**BOARD ACTION REPORT – APPEALABLE ITEM**

**Project Name:** 912 Palm Trail  
**Project Location:** 912 Palm Trail  
**Request:** Class V Site Plan Modification Landscape Plan, and Architectural Elevations associated with the construction of 10 townhomes.  
**Board:** Site Plan Review and Appearance Board  
**Meeting Date:** April 12, 2017

**ITEM:** 912 Palm Trail (2017-001) – Approval of a Class V Site Plan Modification and associated Landscape Plan, Architectural Elevations and Waiver request

SITE PLAN  
NORTH  
PARCEL

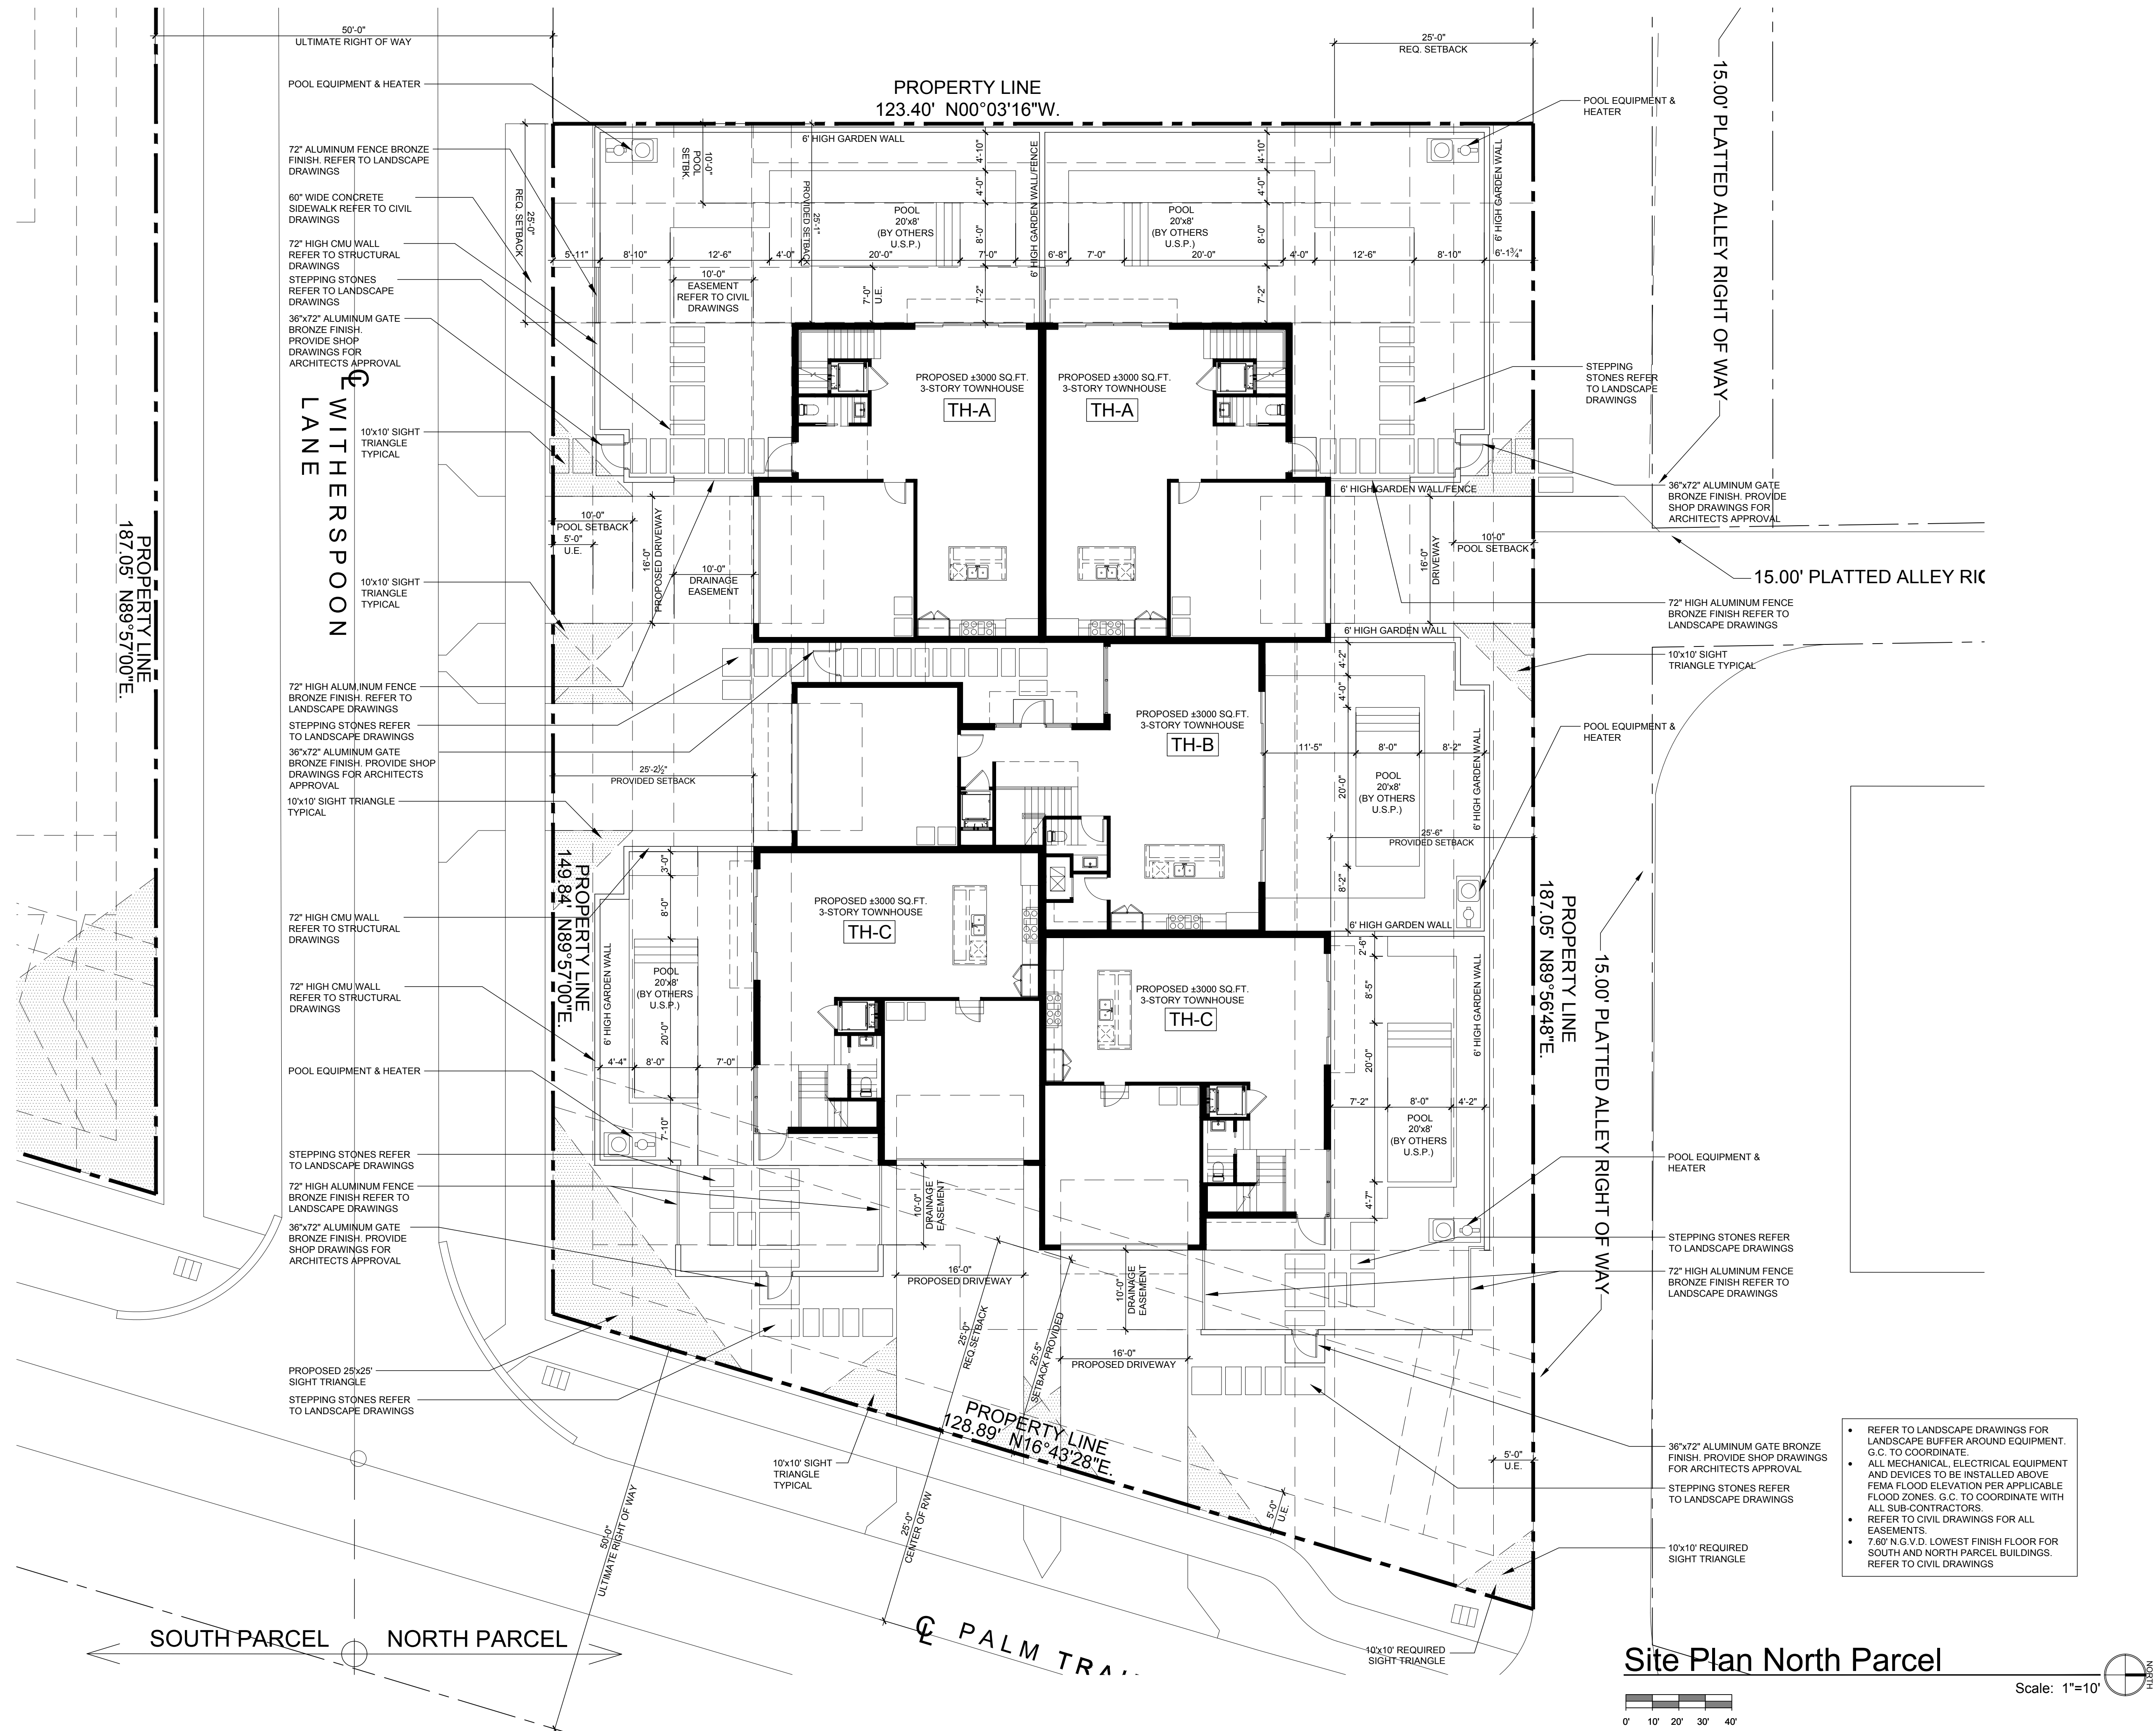
The north parcel intersects an alley way in which only a 10' sight visibility is shown on Palm Trail. As a condition of approval, the plans must indicate a 20' sight visibility on Palm Trail prior to certification.
